## BULLETIN #159

**P-39/P-39A/P39B**

**RELEASE OF NEW CONTROL VALVE AND INNER CONTROL VALVE SPRING COMBINATION**

Old Combination      New Combination

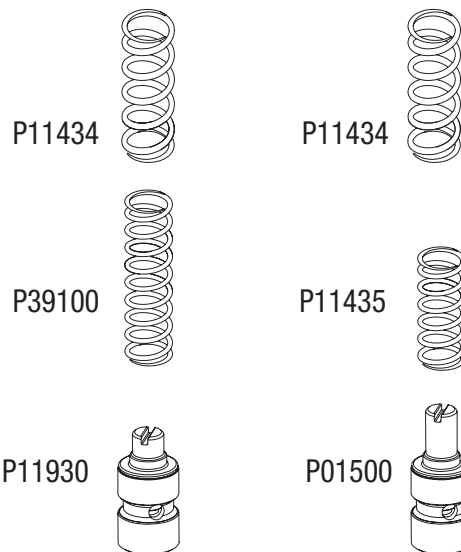
**Pacbrake has released a new control valve and inner control valve spring combination for all P-39/P-39A/P-39B engine brakes.**

The control valve part number P01500 replaces the previously used part number P11930 and will be used with the inner control valve spring part number P11435. The outer control valve spring remains unchanged for all applications. The new parts are available through the Pacbrake distribution system, but existing stock of original control valve and springs can be used until stock is depleted. If updating an engine brake to a new combination, it is imperative all cylinders are done. It is not recommended to interchange the new and old combinations in the same engine brake.

P-39A engine brakes Serial # 070725 and later contain the new spring and control valve combination.

P-39B engine brakes Serial # 101479 and later contain the new spring and control valve combination.
